## Low-pressure flexible connecting assemblies (hose assemblies) for use with medical gas systems

### TECHNICAL CORRIGENDUM 1

Technical corrigendum 1 to International Standard ISO 5359:1989 was prepared by Technical Committee ISO/TC 121, *Anaesthetic and respiratory equipment*, Subcommittee SC 1, *Breathing attachments and anaesthetic machines*.

Figure B.3 — NIST nipple

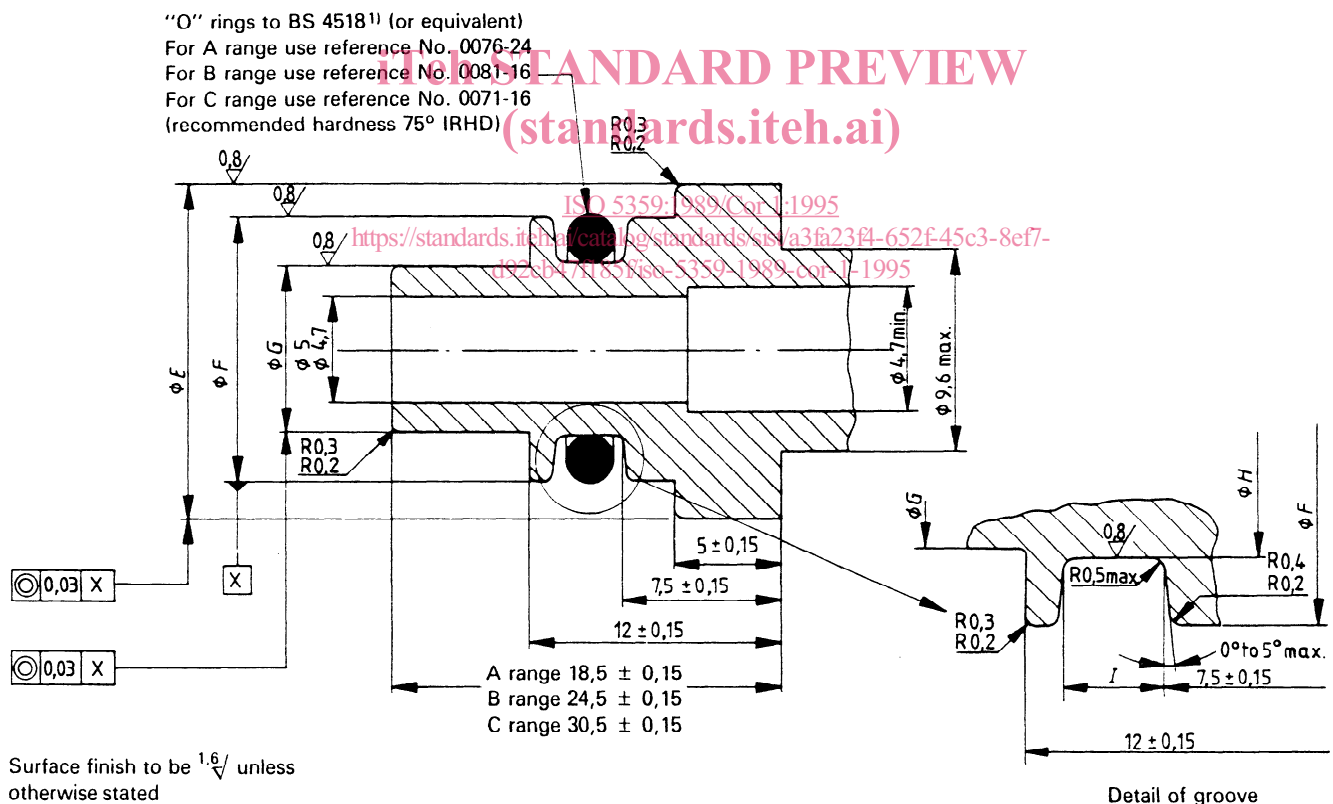
Figure B.3. Delete figure B.3 and substitute the attached new figure B.3.

(Note. The difference is the deletion of the incorrect value '10' at the top of the figure: the position of the step between the different diameters of lumen is therefore not dimensioned.)
